ADDENDUM NO. 02

Project: Franklin Elementary School, 201 West Mill Street, Liberty, Missouri 64068
Alexander Doniphan Elementary School, 1900 Clay Drive, Liberty, Missouri 64068

Project No. 23027
23028

Drawings:
Revised Architectural Sheets: A621, A681

G1 Scale 1/4" = 1'-0" Interior Elevation - Restroom Entry A108 - W

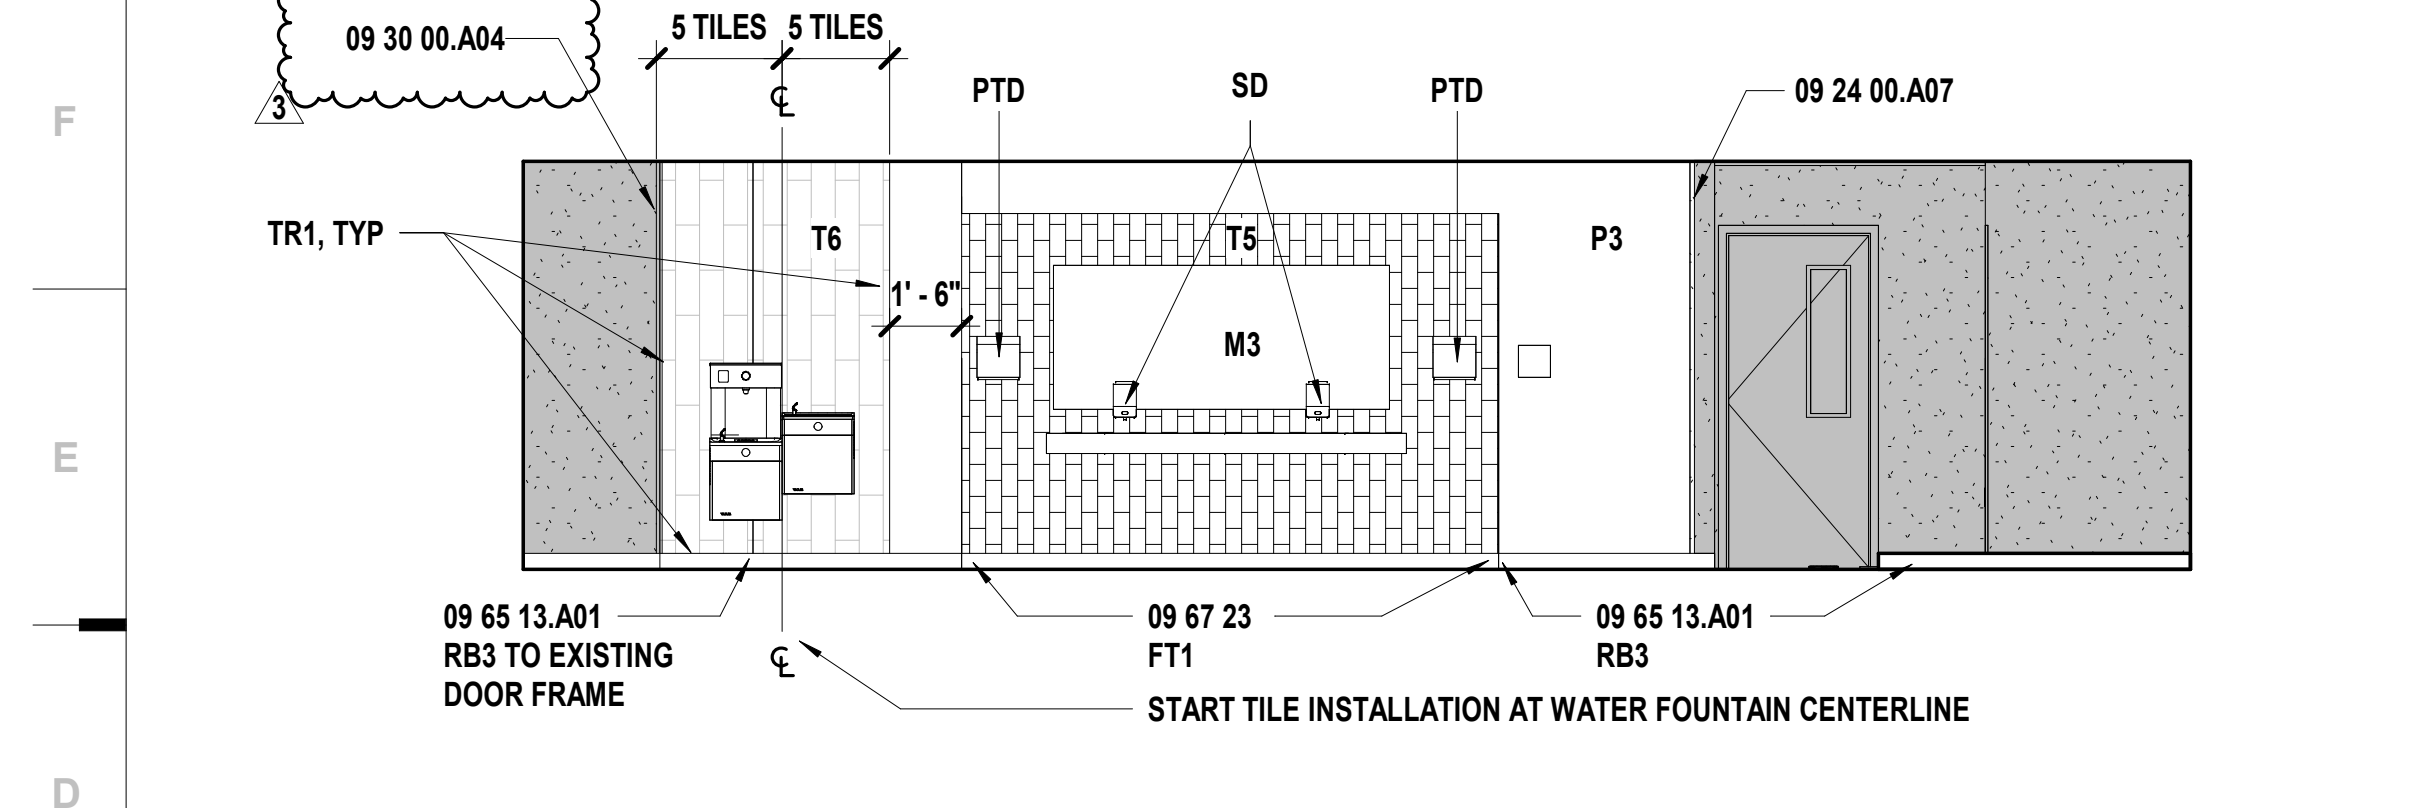
A1.2 REVISED Detail G1A621 Keynote

D1 Scale 1/4" = 1'-0" Interior Elevation - Restroom Entry B121 - E

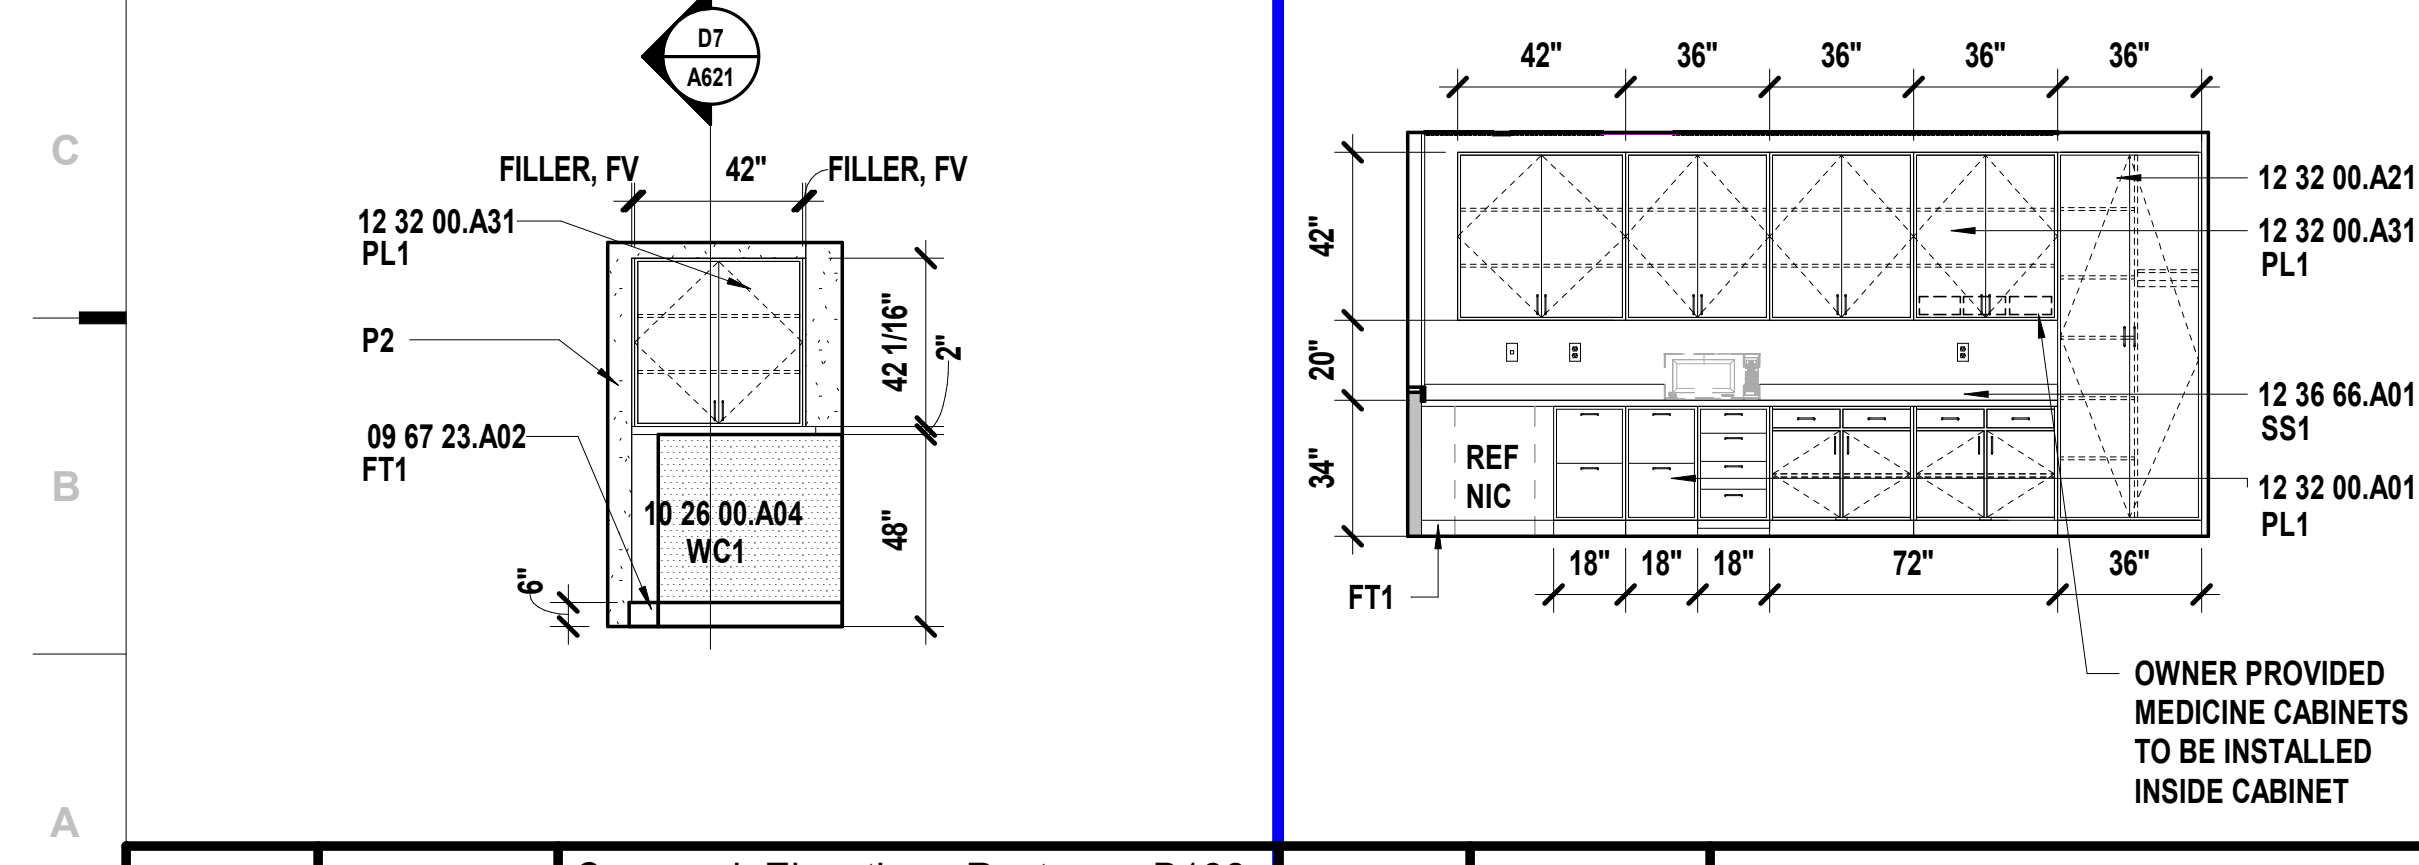
A1.1 REVISED Detail D1A621 Keynote

ROOM FINISH SCHEDULE

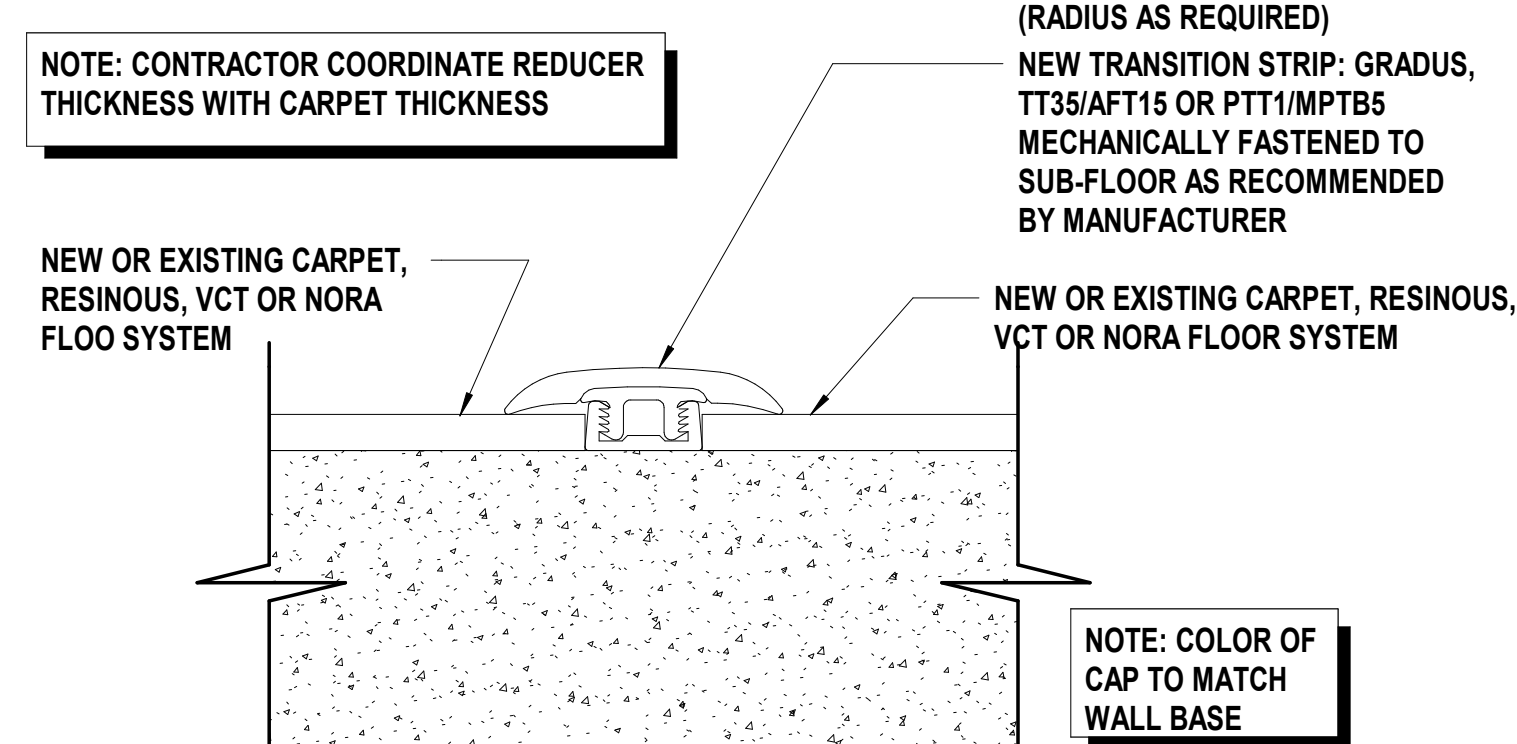
A2.1 REVISED Room Finish Legend B100 Office Floor Finish

| NO | ROOM Name | FLOOR | | WALLS | | | | CEILING Finish | Finish Remarks |
|-------|----------------|---------|------|--------|--------|--------|--------|----------------|----------------|
| B100 | Office | C3 | RB3 | P2 | P2 | P2 | P2 | CLG3 | |
